Response to Written Comments due by September 30, 2015:

### **Re: Decision on Requests by PG&E and the Members of the Hinkley Community to Change Whole House Replacement Water Program and Plume Delineation Requirements**

- A PG&E Comments on Draft Cleanup and Abatement Order
- B Key Elements of Revised Conceptual Site Model for the Western Portion of the Lower Aquifer, Hinkley, California

Prosecution Team's Comments on September 1, 2015 Draft Cleanup and Abatement Order R6V-2015-DRAFT

**Figure 3**  
**Pressure Transducer Data for**  
**Upper Aquifer/Lower Aquifer Well Pairs at MW-23C and MW-92C**  
 Pacific Gas & Electric Co. Hinkley Compressor Station

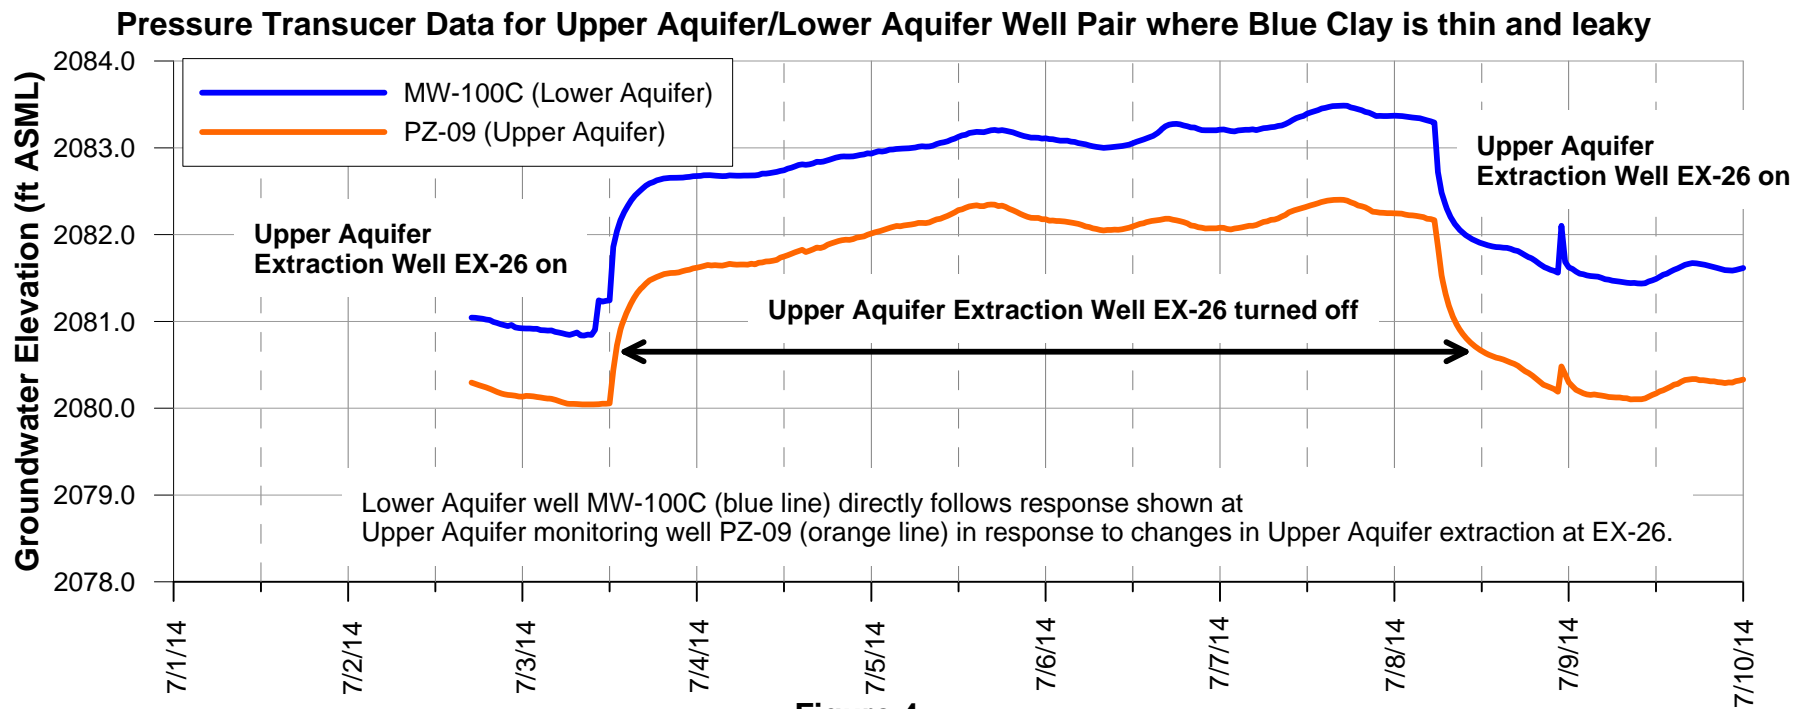
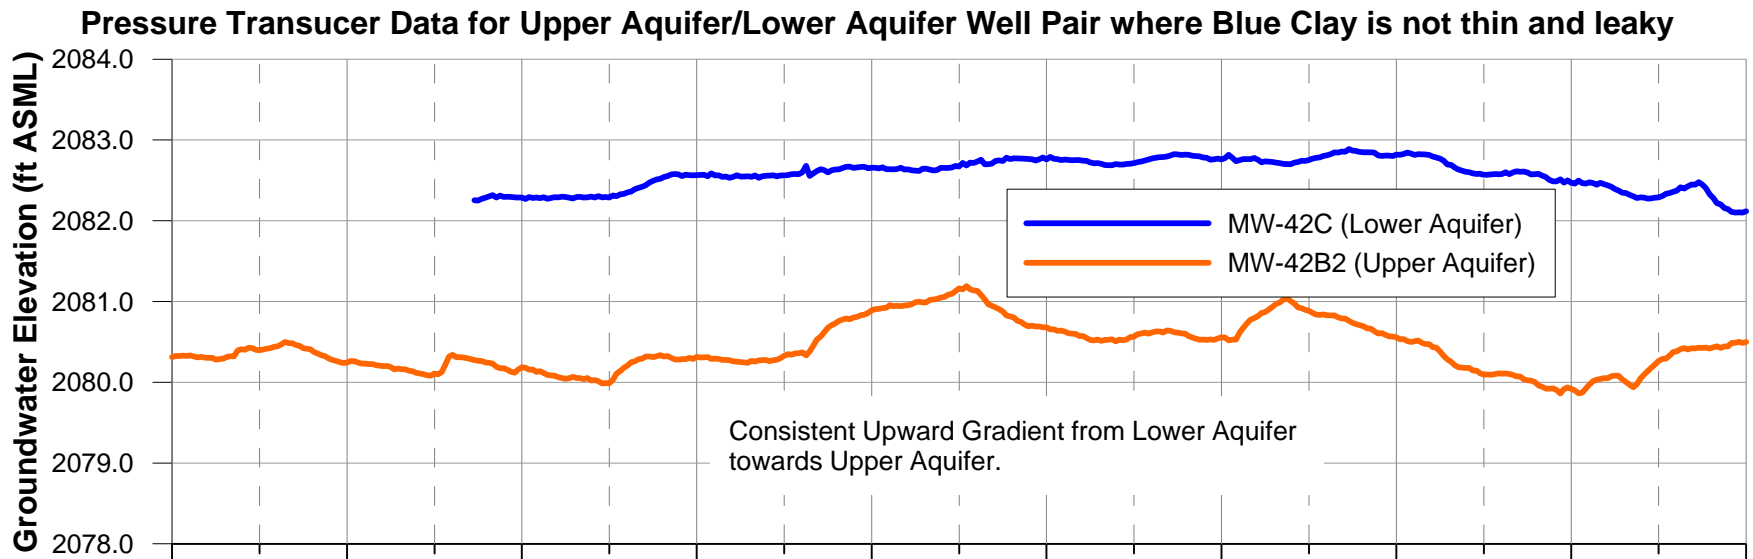
Figure 3 in the attached memo shows hydrographs for upper aquifer/lower aquifer well pairs MW-23B/MW-23C and PZ-08/MW-92C, respectively. The blue clay acts as an aquitard at MW-23C, as demonstrated by the consistently 1-foot higher groundwater elevation at MW-23C than the upper aquifer well MW-23B, demonstrating an upward hydraulic gradient (top panel of Figure 3). On the other

hand, the hydrograph for the PZ-08/MW-92C well pair shows comparable groundwater levels at both the upper and lower aquifer wells without a significant vertical gradient like the MW-23B/23C hydrograph (bottom panel Figure 3). The hydrograph for PZ-08/MW-92C is corroborated by the observation of thin and sandy blue clay in this area and suggests that the blue clay does not act as an aquitard in this area. Figure 4 shows hydrographs for upper aquifer/lower aquifer well pairs MW-42B2/MW-42C and PZ-09/MW-100C, respectively. Like the MW-23B/MW-23C hydrograph, lower aquifer well MW-42C shows a consistently higher groundwater level (more than 1.5 feet) than upper aquifer well MW-42B2, indicating that the blue clay acts as an aquitard in this area. While an upward gradient is shown in the hydrograph for PZ-09/MW-100C (blue line above orange line), both wells respond equally to changes in upper aquifer groundwater extraction at upper aquifer extraction well EX-26, indicating that the blue clay does not act as an aquitard in this area.

Figure 3 shows hydrographs for Upper and Lower Aquifer well pairs MW-23B/MW-23C and PZ-08/MW-92C, respectively. The blue clay acts as an aquitard at MW-23C, as demonstrated by the consistently 1-foot higher groundwater elevation at MW-23C than the Upper Aquifer well MW-23B, demonstrating an upward hydraulic gradient (top panel of Figure 3). On the other hand, the hydrograph for the PZ-08/MW-92C well pair shows comparable groundwater levels at both the Upper and Lower Aquifer wells without a significant vertical gradient like the MW-23B/23C hydrograph (bottom panel Figure 3). The hydrograph for PZ-08/MW-92C is corroborated by the observation of thin and sandy blue clay in this area and suggests that the blue clay does not act as an aquitard in this area. Figure 4 shows hydrographs for Upper and Lower Aquifer well pairs MW-42B2/MW-42C and PZ-09/MW-100C, respectively. Like the MW-23B/MW-23C hydrograph, Lower Aquifer well MW-42C shows a consistently higher groundwater level (more than 1.5 feet) than Upper Aquifer well MW-42B2, indicating that the blue clay acts as an aquitard in this area. While an upward gradient is shown in the hydrograph for PZ-09/MW-100C (blue line above orange line), both wells respond equally to changes in Upper Aquifer groundwater extraction at Upper Aquifer extraction well EX-26, again indicating that the blue clay does not act as an aquitard in this area.

### PG&E Chromium Plume Maps Over Time

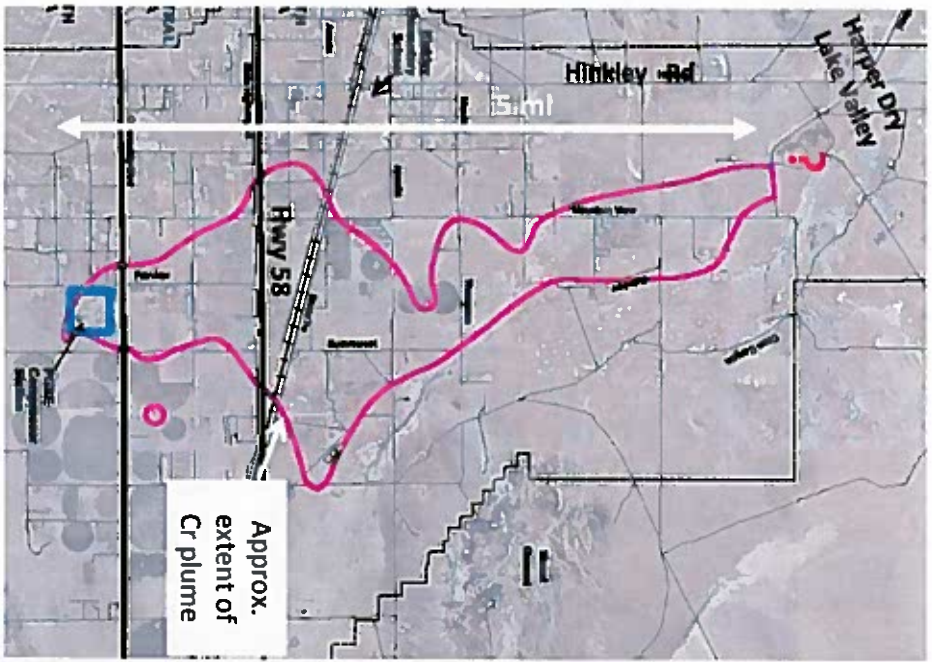
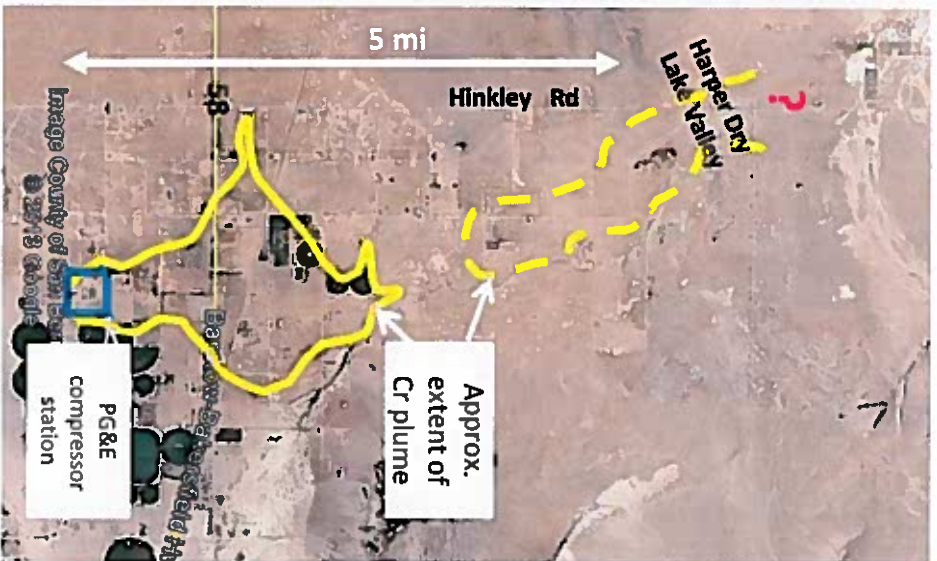
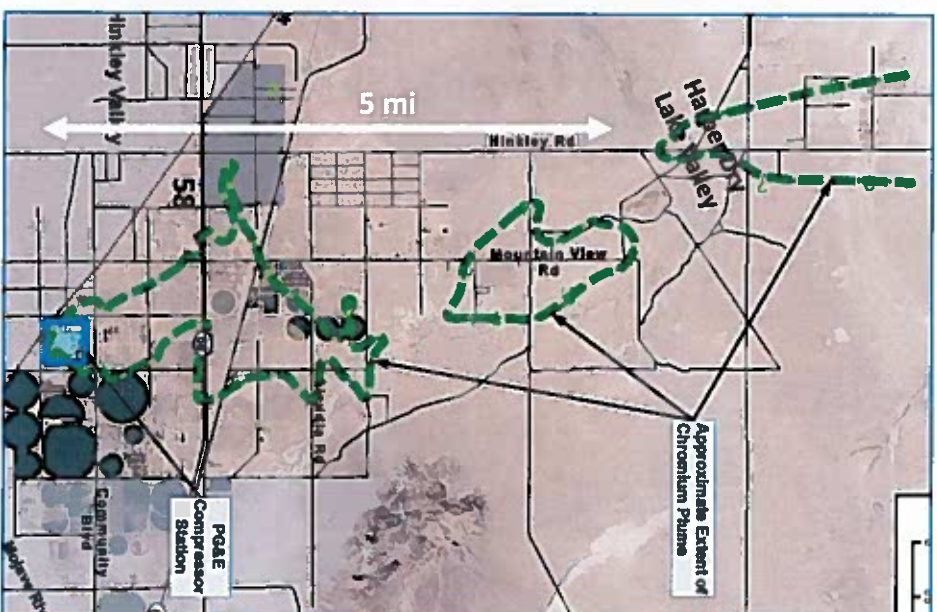
PG&E has claimed that the northern two plumes on current maps are not related to historical chromium releases at the Hinkley compressor station. Yet, as seen in the figure as Attachment 2, the three maps show the progression of the chromium plume over time. Chromium in groundwater was mapped as one large plume connected to the compressor station in first quarter 2012, just 3½ years ago. In 2013, the plume was drawn divided as two separate plumes due to remedial actions. In 2014, the northern plume is shown as divided again but that may just be due to lack of monitoring data in the east side of the Hinkley Gap.

Figure 2.—Study area location.

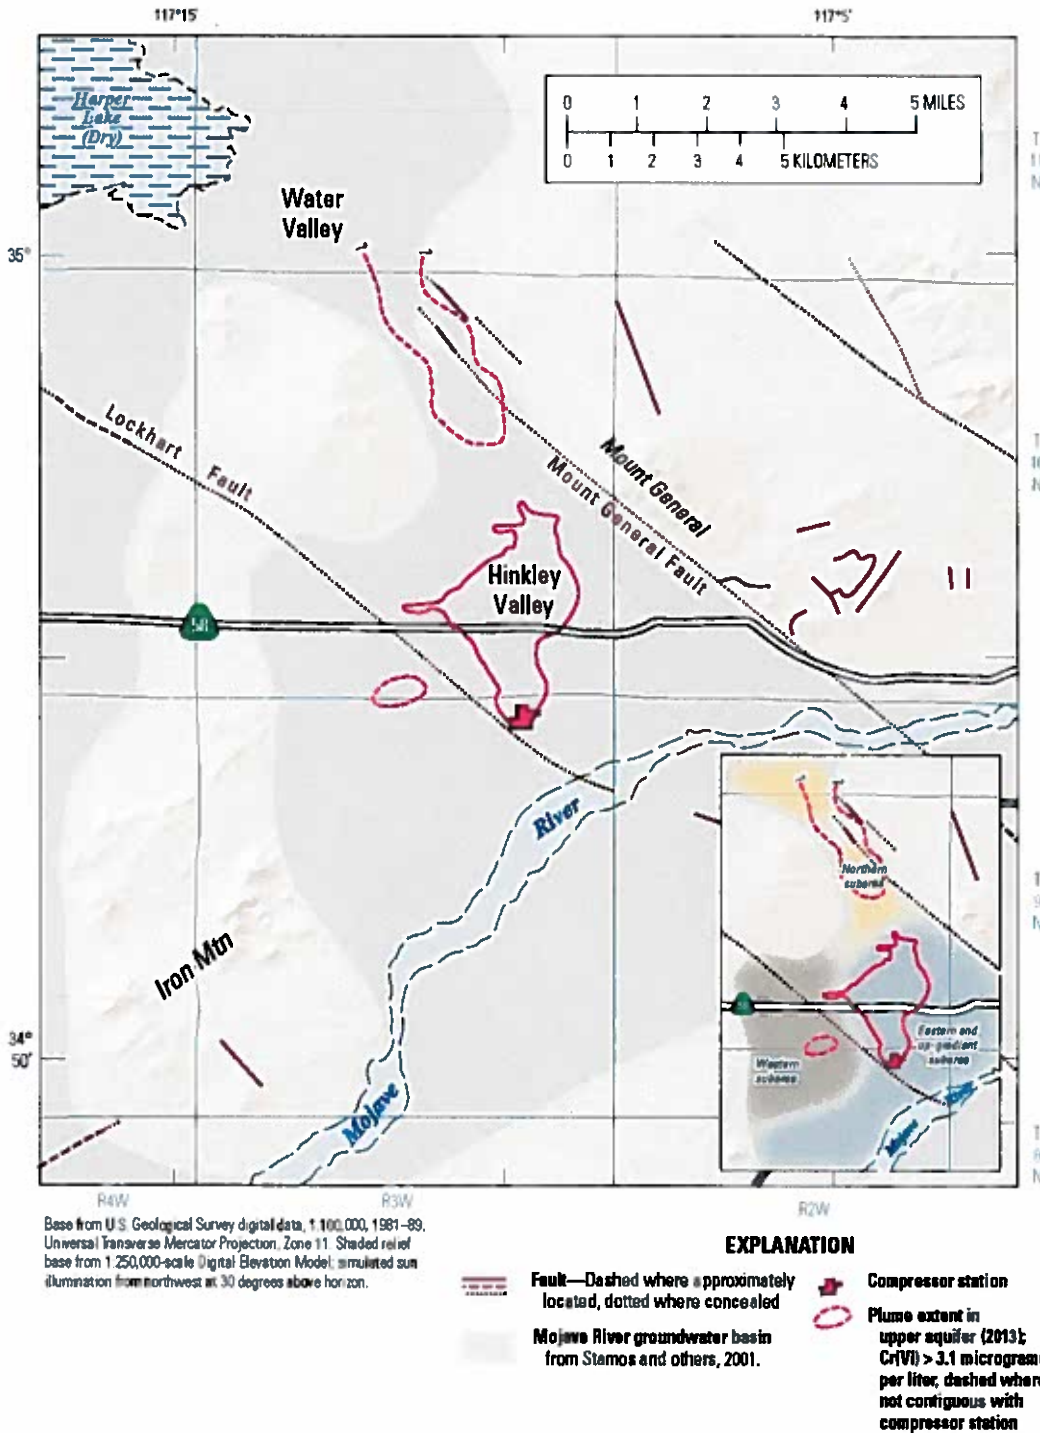
The northern plume is considered as real in the U.S. Geological Survey's (USGS) proposal for chromium background study. The 2014 study proposal includes a map on Figure 2 (Attachment 4) showing the chromium plume boundary lines in groundwater in the North Hinkley Valley and Harper Dry Lake Valley. The explanation for the map states "Plume extent in upper aquifer (2013); Cr(VI) >3.1 micrograms per liter, dashed where not contiguous with compressor station." This latter part indicates the USGS currently considers the dashed plume in the north to be related to the compressor station. The current background study will be establishing just how wide and long the northern plume boundary lines extend.
